<b>Device</b>	<b>XC164CS-32F</b>
<b>Marking/Step</b>	<b>(E)ES-BB, BB</b>
<b>Package</b>	<b>PG-TQFP-100-5, P-TQFP-100-16</b>

This Errata Sheet describes the deviations from the current user documentation.

Figure 1 Example for Case 2: Interrupt Service for Task C delayed

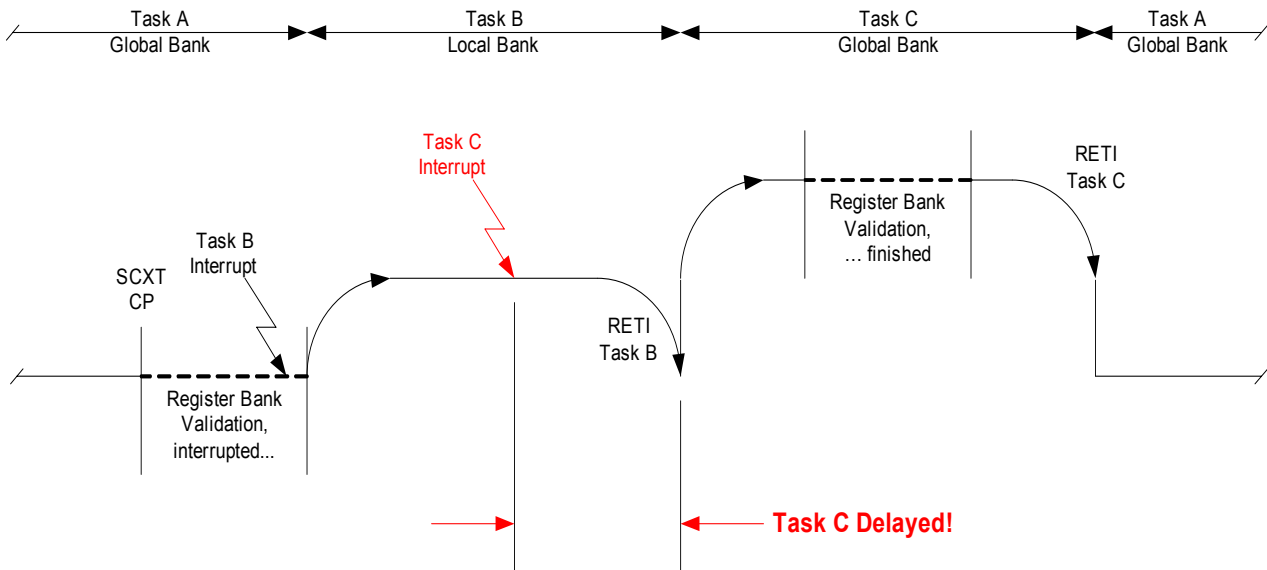
Case 2 (see also Figure 1):

- The Context Pointer CP is written to (e.g. by POP, MOV, SCXT .. instructions) within a routine (Task A) that uses a **global** register bank (bit field PSW.BANK = 00<sub>B</sub>), i.e. the context for this routine will be modified,
- This context switch procedure (19 cycles) is interrupted by an interrupt request (Task B) which is programmed (with GPRSELx = 1X<sub>B</sub>) to automatically use one of the **local** banks via the bank selection registers BNKSEL0..3 (i.e. the interrupting routine has a priority level  $\geq 12$ ),
- Before the corresponding interrupt service routine is finished, another interrupt request (Task C) occurs which is programmed (with GPRSELx = 00<sub>B</sub>) to automatically use the **global** bank via the bank selection registers BNKSEL0..3 (i.e. the interrupting routine has a priority level  $\geq 13$ ).

In this case service of this interrupt request (for Task C) is delayed until bit field PSW.BANK becomes 00<sub>B</sub> after executing the RETI instruction at the end of the routine (Task B) using the local bank.

### Workaround for Case 2

When using both local and global register banks via the bank selection registers BNKSEL0..3 for interrupts on levels  $\geq 12$ , ensure that there is no interrupt using a global register bank that has a higher priority than an interrupt using a local register bank.
